APPLICATION NO.	FILING DATE	FIRST NAMED INVENTOR	ATTORNEY DOCKET NO.	CONFIRMATION NO.
10/789,689	02/27/2004	Takehiro Okanaka	KASAP047	9344

Office Action Summary

DETAILED ACTION

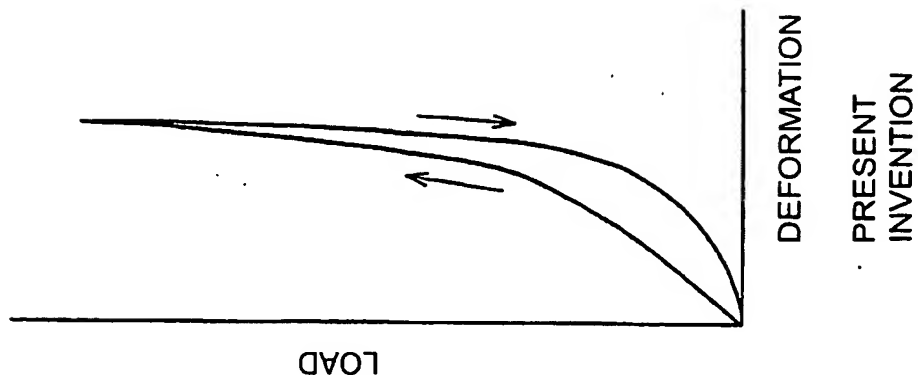
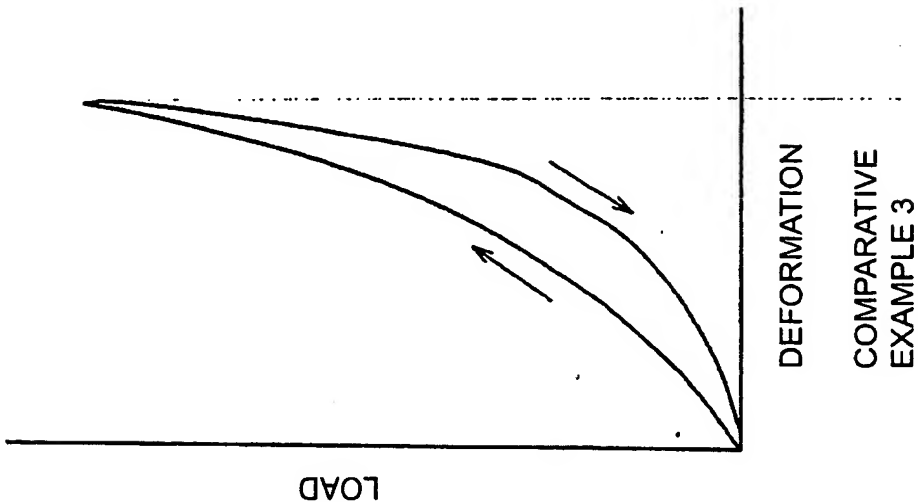
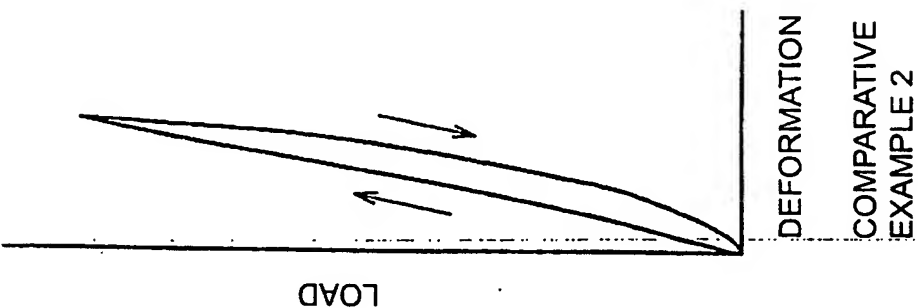
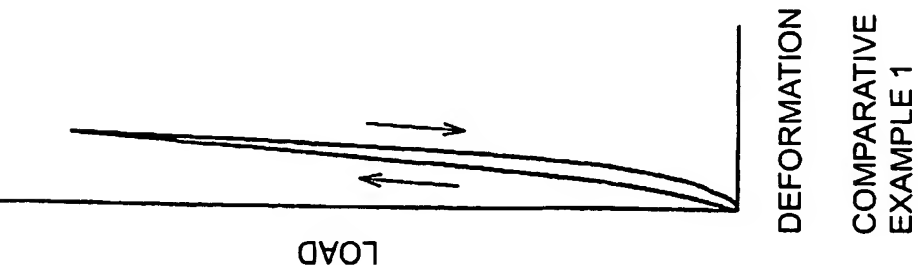
2. It is unclear about the status of figures 9A, 9B, 9C, 10A, 10B, 11A, 11B, 11C, 11D, 12C, 12D, 12E and 12F. It appears from the specification that these figures should be prior art since they are similar to the stopper of figure 13, the stopper of JP9-166175 and the stopper of JP2001-349368. However, Applicant fails to specify that these figures are prior art or not. Furthermore, Applicant does not specify that these figures represent different embodiments of the instant invention. In fact, the specification only mentioned one embodiment of the instant invention in figures 1, 2, 3, 4, 5, 6, 7A, 7B, 8A, 8B, 8C, 9D, 12A and 12B. It is required that an explanation and/or

amendments to the specification and the drawings be accompanied to the Response to this Office Action. Applicant amended figures 9A, 9B, 9C, 10A, 10B, 11A, 11B, 11C, 11D, 12C, 12D, 12E and 12F to include labels "Comparative Example 1", etc. in the Response dated 6/30/05. These labels do not specifically identify these figures as prior art or as different embodiments of the present invention. Hence, the objection is repeated above for figures 9A, 9B, 9C, 10A, 10B, 11A, 11B, 11C, 11D, 12C, 12D, 12E and 12F. The amended figures 9D, 12A and 12B including labels "Present Invention" have been approved.

NOT approved
XLN
9/6/05

Corrected drawing sheets in compliance with 37 CFR 1.121(d) are required in reply to the Office action to avoid abandonment of the application. Any amended replacement drawing sheet should include all of the figures appearing on the immediate prior version of the sheet, even if only one figure is being amended. The figure or figure number of an amended drawing should not be labeled as "amended." If a drawing figure is to be canceled, the appropriate figure must be removed from the replacement sheet, and where necessary, the remaining figures must be renumbered and appropriate changes made to the brief description of the several views of the drawings for consistency. Additional replacement sheets may be necessary to show the renumbering of the remaining figures. Each drawing sheet submitted after the filing date of an application must be labeled in the top margin as either "Replacement Sheet" or "New Sheet" pursuant to 37 CFR 1.121(d). If the changes are not accepted by the examiner, the applicant will be notified and informed of any required corrective action in the next

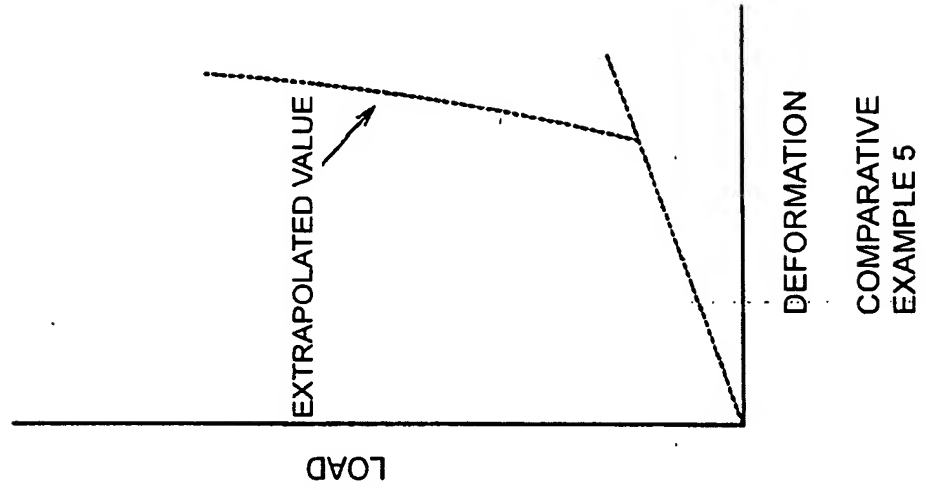
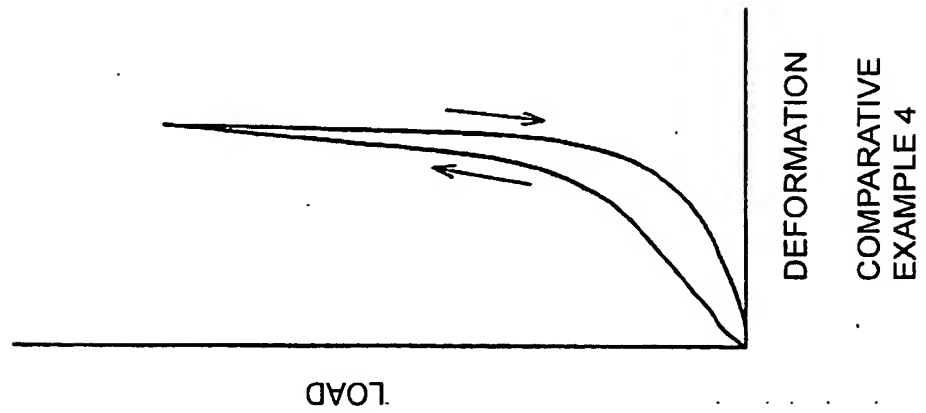
NOT approved
XLN
9/6/05

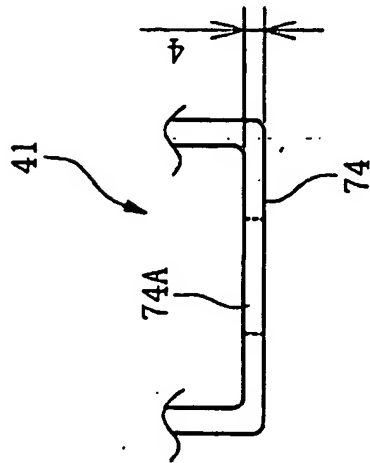
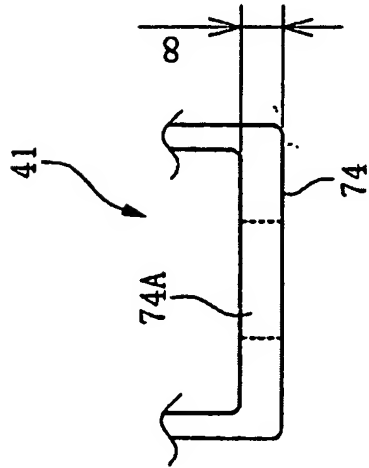
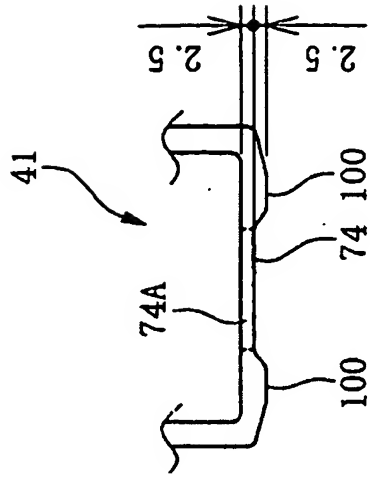
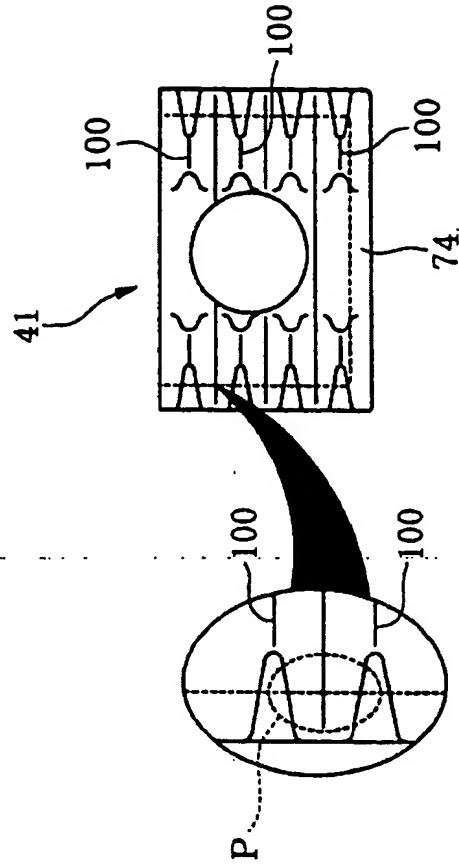
NOT approved
XLN
9/6/05

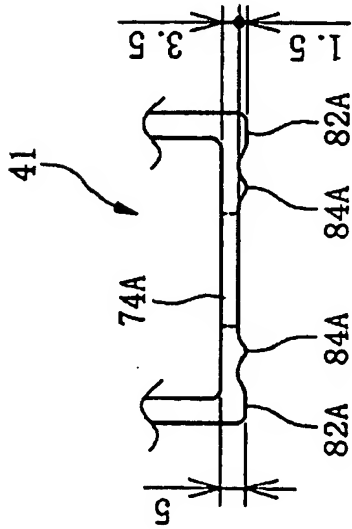
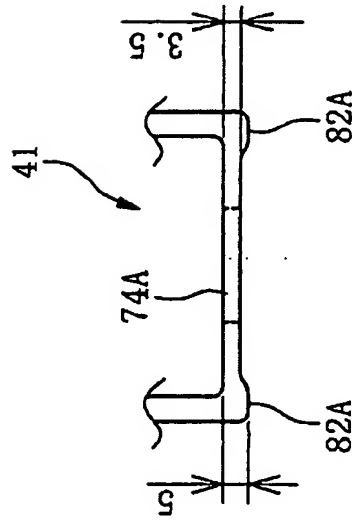
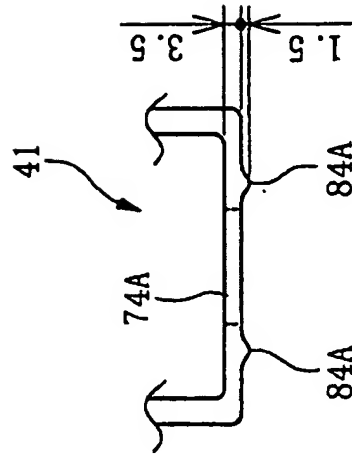
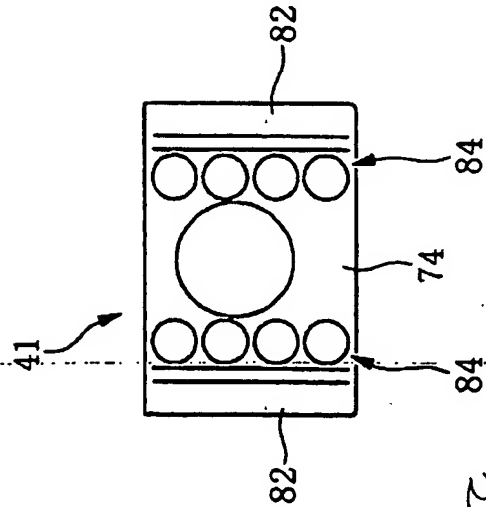
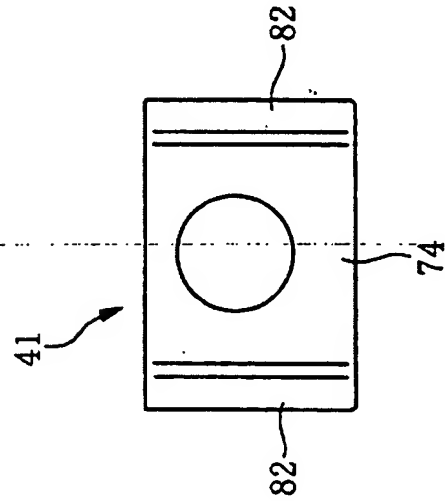
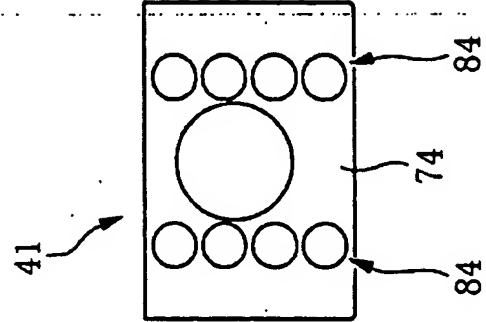
Not approved
XLN
9/6/05

FIG. 13

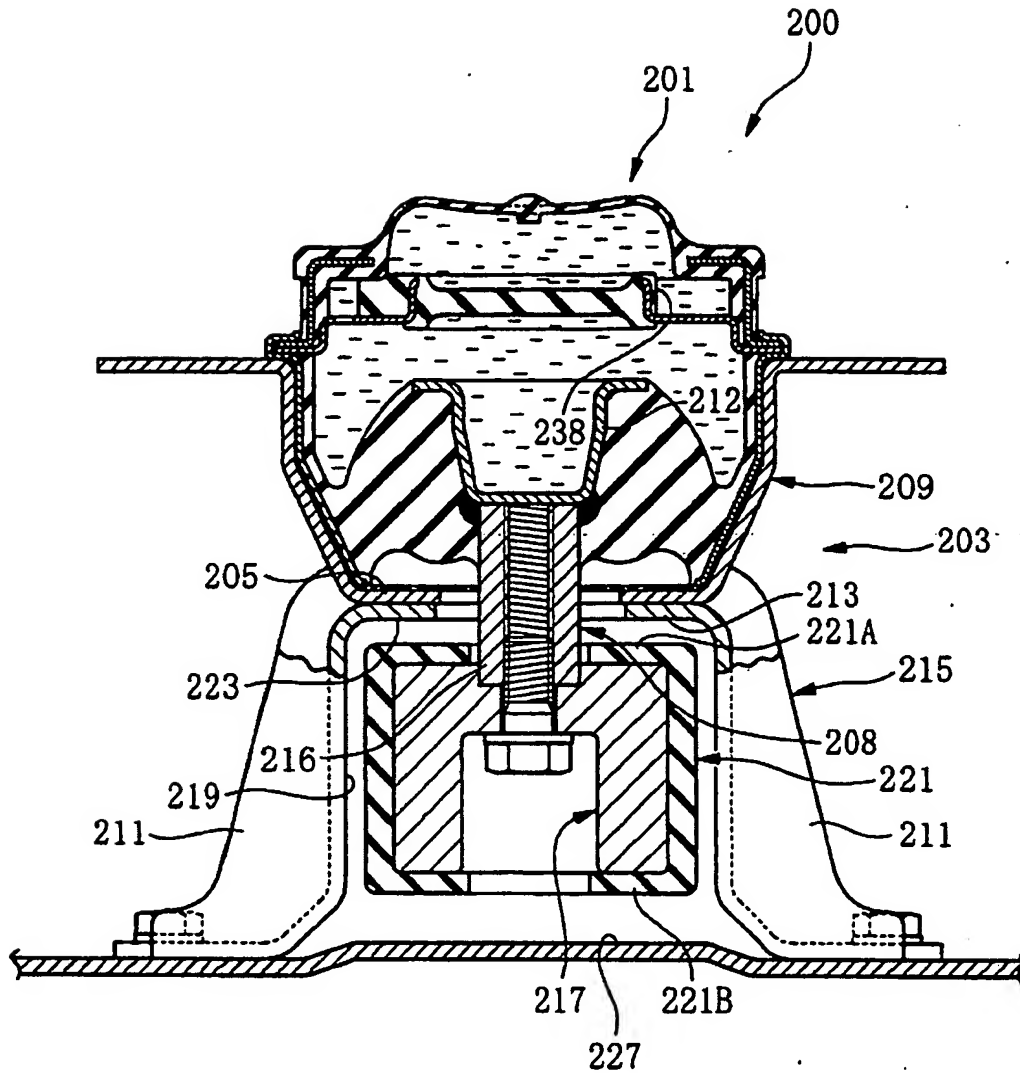
NOT approved
XW
9/6/05
